Additional Credits Requirement for Fossil Fuel Path

Example from Washington State Commercial Building Energy Modeling Analysis (prepared by 2050 Partners)

Apartment-Midrise

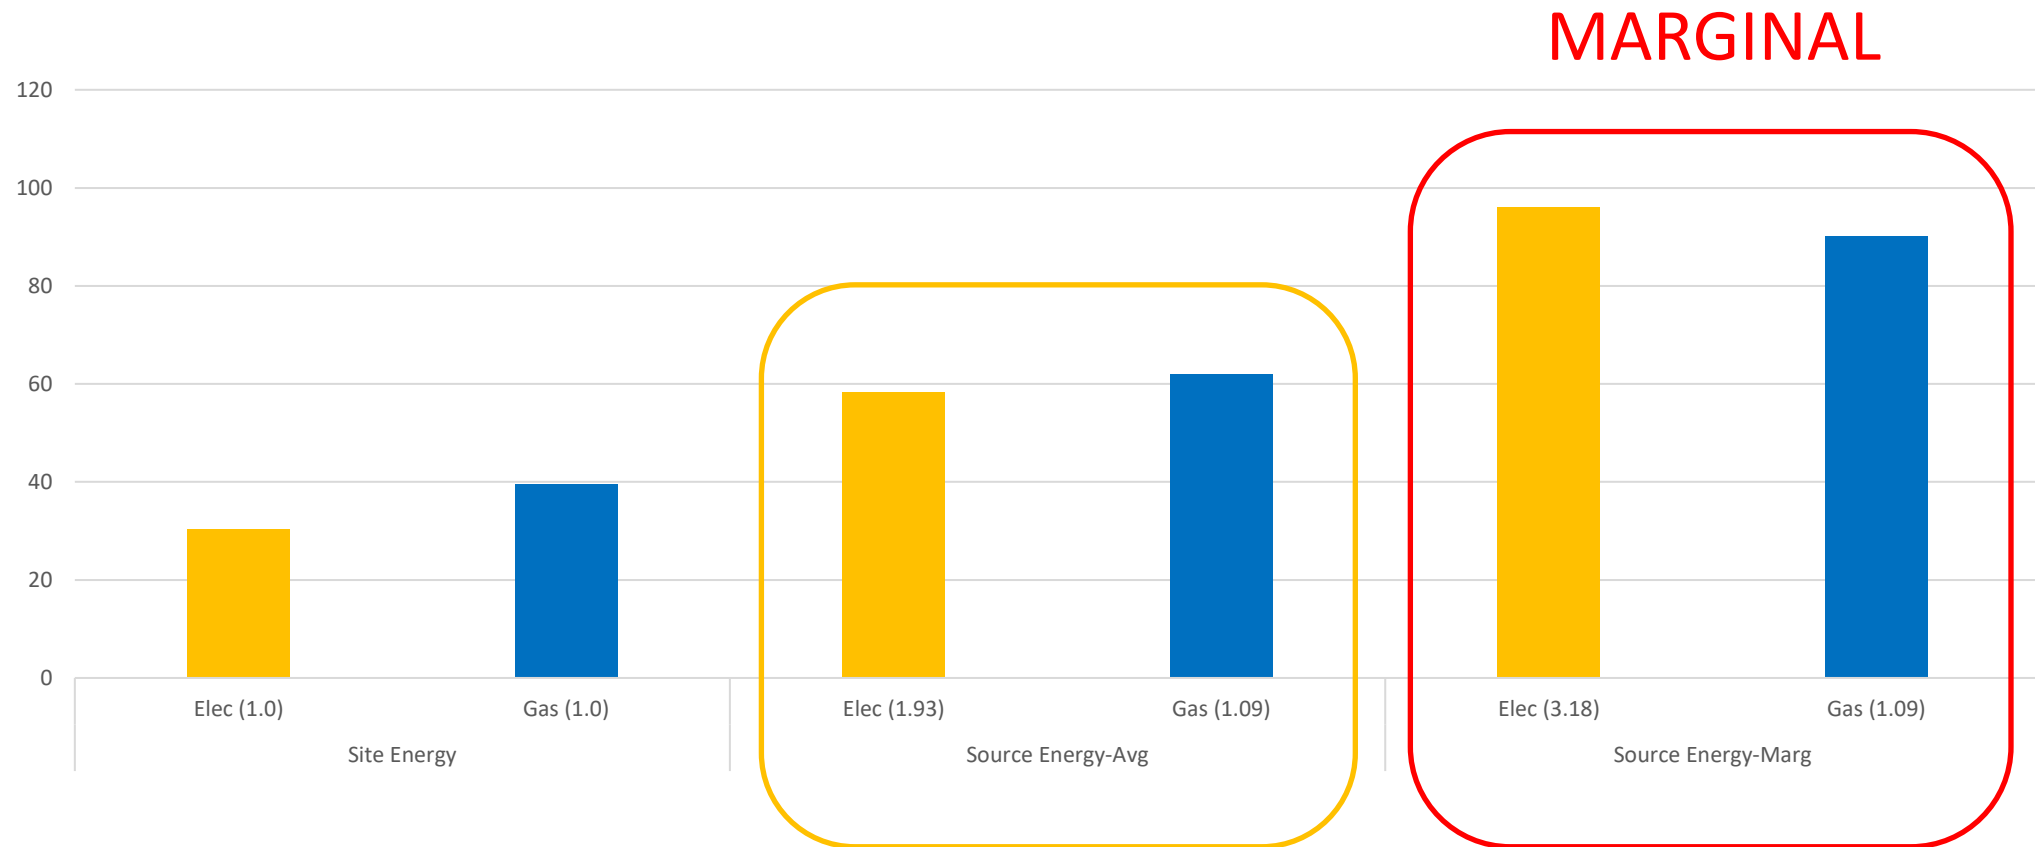
- Additional credits required for the fossil fuel path are based on site energy using a heat pump baseline.
- Site energy ignores all upstream losses associated with fuel extraction, generating losses and transmission and distribution losses.
 - These losses are approximately 1/2 when considering all sources of electricity, including renewables, and about 2/3rds when considering only the marginal resources in the NWPP.
- If additional credits for fossil fuels is to be compared to a heat pump baseline, it should be done on a source energy basis.

- Using site energy as the basis for calculating additional credits ignores upstream losses and does not fairly compare electric and gas space and water heating (apples and oranges)
- To have a truly fair comparison, recalculate the additional credits using source energy as the basis.
- Further, for new construction, the new electrical load affects only the additional energy required from marginal resources and does not affect base-loaded and wind or solar resources.
- Therefore, a source energy factor for electricity should be based on marginal resources (3.18)
